Technical Service Information

FORD CD4E/MAZDA LA4A-EL FRONT SEAL BLOW-OUT OR CONSTANT LEAK

Figure 1

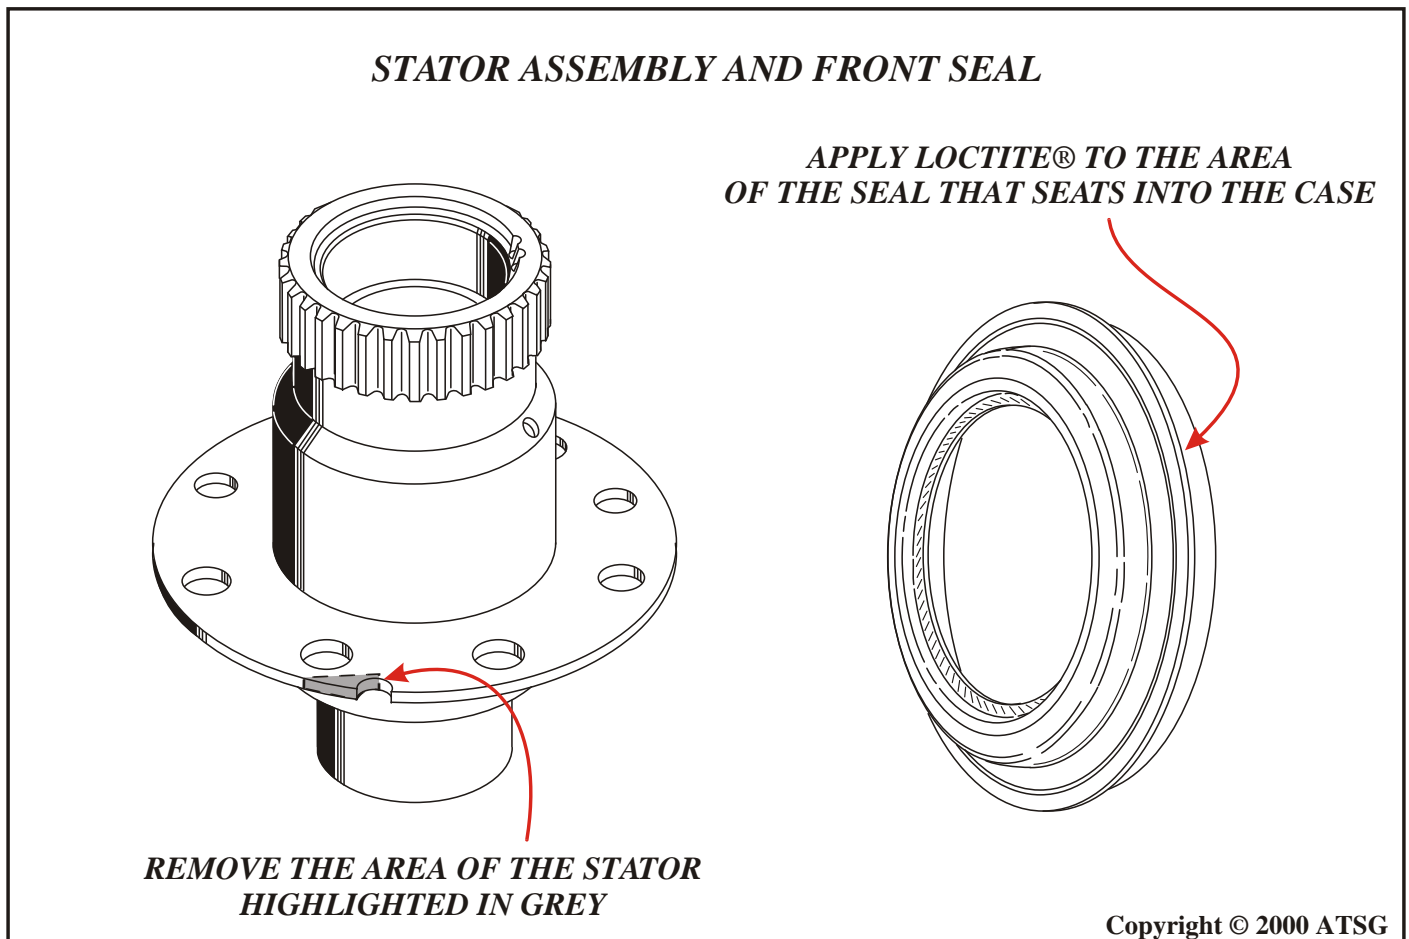
1. Remove the Stator from the front of the bellhousing. Remove the area highlighted in grey, as shown in Figure 1, with a bench grinder.

2. With a 3/16" or 13/64" drill bit, drill at an angle through the area shown in Figure 2.
3. Refer to Figure 3 to see the modified drain back passage from the front side of the bellhousing.
4. Apply Loctite ® to the front seal before installing it into the bellhousing as shown in Figure 1.
